Department of Energy

THE 4843 ALKALI METAL STORAGE FACILITY CLOSURE PLAN, REVISION 0, NOTICE OF DEFICIENCY RESPONSE TABLE (S-4-1)

**4843 ALKALI METAL STORAGE FACILITY CLOSURE PLAN REVISION 0
NOTICE OF DEFICIENCY RESPONSE TABLE**

Review Draft
February 23, 1993
Page 1 of 24

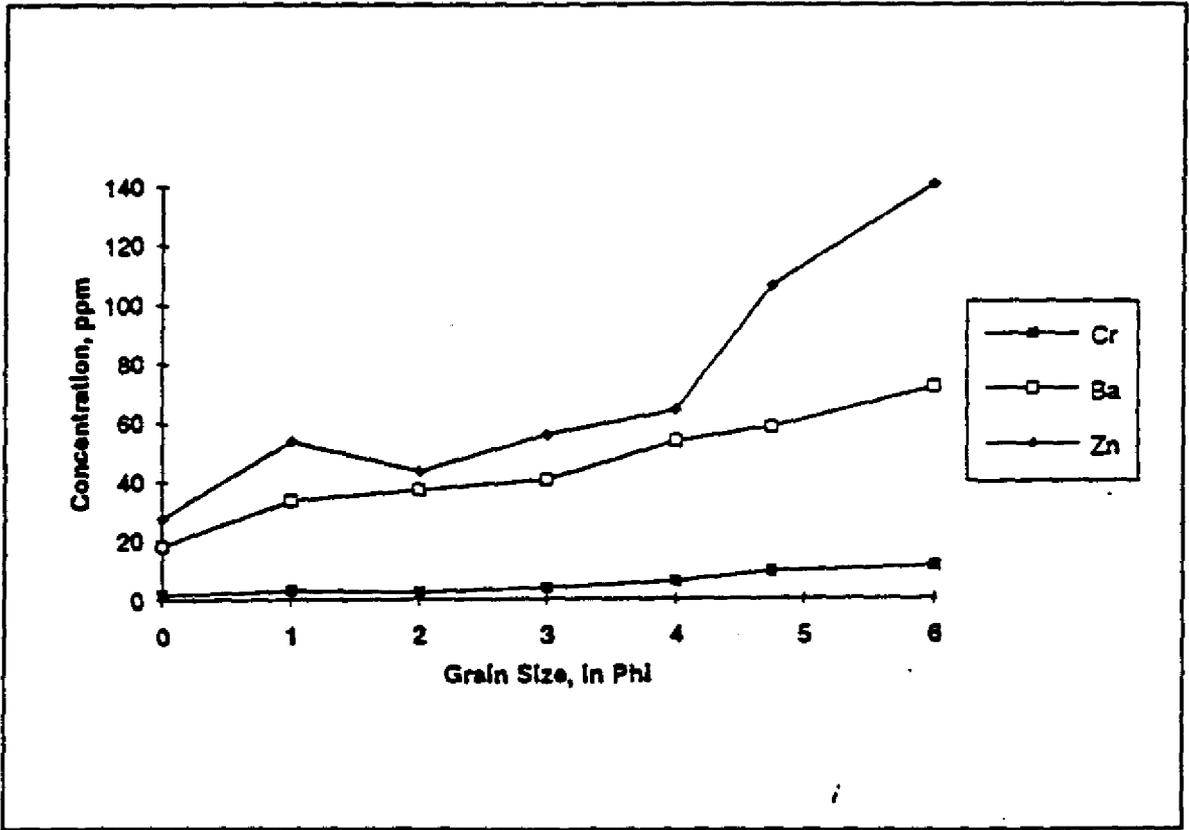
Grain size is another potential source of analytical variation when using strong acid digestion methods, such as 3050. Because the acid attacks the surface of particles most readily, the total surface area (generally, a function of grain size) will influence the amount of material dissolved. Figure 1 illustrates this effect. However, the TCLP extraction solution is less likely to mobilize the naturally occurring constituents, regardless of the physical or chemical nature of the media.

The effect of grain size on analytical values will probably be substantially smaller when using the TCLP extraction, although no data is available to test this hypothesis. The TCLP solution was designed to leach potentially mobile constituents, which would likely include any contaminants deposited on concrete. The amount of dissolution of these materials would be independent of grain size and mineral composition of the sample aggregate. Therefore, more consistent analyses would result when using TCLP extraction for detecting contamination, because neither the composition nor the grain size of the aggregate would influence the result.
